Ref: Application 2014/5873/P

OBJECTION TO PLANNING APPLICATION 2014/5873/P

We write in respect of Planning Application 2014/5873 (the "Application") in respect of the demolition and rebuilding and extension of 18-26 Hatton Wall (the "Proposed Development") as the resident leaseholders of Flat 3, Hatton Wall House, 28A Hatton Wall, which occupies the third and floor floors of the adjoining building to the west of the proposed development ("Flat 3"). Flat 3 is marked in yellow in the attached plans submitted with the Application in hard copy by post.

Flat 3, Hatton Wall House

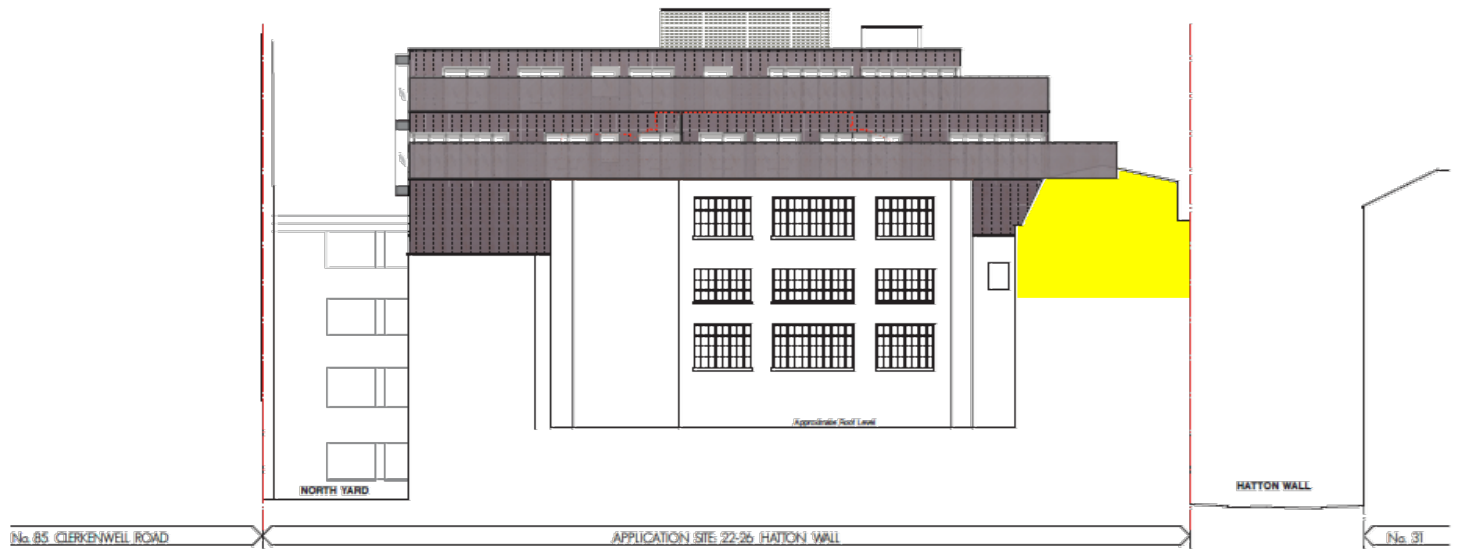
A significant contributor to the residential amenity of Flat 3 is the penthouse balcony that faces the courtyard and west elevation of the Proposed Development. As the existing building is only slightly higher than Hatton Wall House, an additional two floors in such close proximity to this balcony will have an oppressive and claustrophobic effect and causing significant detriment to amenity of this feature.

The Proposed Development entails the extension of the site by two further stories—two stories higher than any other building on Hatton Wall—with full balconies wrapping around both stories on the elevation facing Flat 3.

Whilst the balcony of Flat 3 is perpendicular to the side of the Proposed Development, the distance between the two buildings is significantly less than 18m (estimated at less than 6 metres). Note that this loss of privacy would not only be also suffered by Flat 3, but also by the units on Leather Lane with windows directly facing this elevation of the Proposed Development.

While recognising that the current plans for the Proposed Development attempt to mitigate this loss of privacy by the inclusion of perforated screens, the approximately waist-high height of the proposed screening only serves to partially obstruct views into the newly proposed residential units, and leaves Flat 3’s balcony and the living area behind visible through the large sliding windows completely exposed.

In combination with the extreme lateral proximity and the extension in building height by two stories towering over the existing roof line as experienced from properties facing the courtyard, this is an unacceptable loss of privacy and amenity to Flat 3.

- Submission a satisfactory daylight and sunlight report that satisfies the Camden Local Area Requirement for such by assessment of the flats in Hatton Wall House
- Revision of the plans for the Proposed Development to ensure preservation of Flat 3's residential amenity and privacy. Having studied the current plans for the Proposed Development, we struggle to imagine how any adjustments to the proposed two story extension of the building, apart the extension's complete omission, might mitigate these issues in an acceptable way.
